Bryant & Stratton
7805 Oswego Road
Clay, NY 13041

Addendum 3
April 26, 2019
Page 1 of 1

This Addendum is issued by the Architect and shall become part of the Contract Documents and is also subject to the terms and conditions set forth in Divisions 0 and 1.

C-1.02
 Scale As Noted

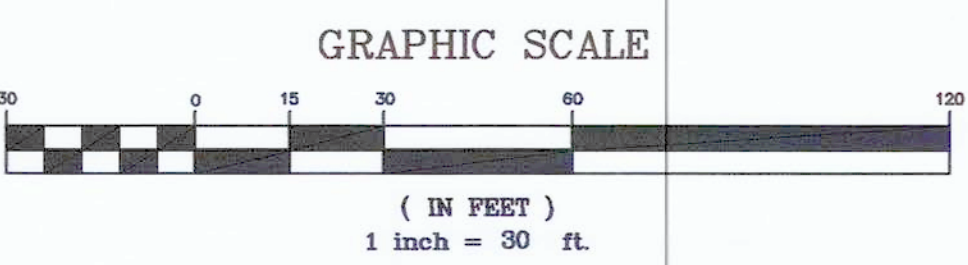
- Item No. 1: Refer to A-201. **Revise** note “EXISTING BLOCK TO BE PAINTED” to “EXISTING BLOCK TO BE PAINTED. PATCH, REPAIR, AND REPOINT EXISTING BLOCK AS NECESSARY PRIOR TO PAINTING.” Revision to apply to all elevations.
- Item No. 2: Refer to Civil Drawings. **Clarification**, Gray colored sealer to be GAF StreetBond SB120 Pavement Coating or approved equal. Install per manufacturer recommendations.
- Item No. 3: Refer to attached marked up C-1.02 **Add** note “REMOVE AND REPLACE EXISTING BROKEN CURB.
- Item No. 4: Refer to Civil Drawings. **Clarification**, planters are to be provided with annual plantings.
- Item No. 5: Refer to A-401: Optional fireplace cladding in leu of white concrete panel: Best Tile, Plane Collection, 30x60 in True White

Date Requested	Drawing Ref.	RFI	RESPONSE/ COMMENT
4/18/2019	C-102	C-102 grey sealer for asphalt - do you have a specification of what you would like for a material?	Gray colored sealer to be GAF StreetBond SB120 Pavement Coating or approved equal
4/18/2019		Will the access control doors be monitored for door position, i.e. door propped open, forced entry, etc.?	
4/19/2019	SS-101 4	P- Please refer to the SS101 & P4 drawings- There appears to be a clearance issues with the underground plumbing @ CL A.5/2.8. Please Advise	Piping may be rerouted in field as necessary to accommodate for column location. Coordinate with all other trades to ensure proper installation as structural drawings were not available until after Plumbing drawings were completed. -EBS
4/22/2019		I visited the site today and the building is extremely musty. The drywall on the perimeter that is depicted to just be patched and refinished is in rough shape and in all likelihood contains mold. Do you really want to keep this drywall?
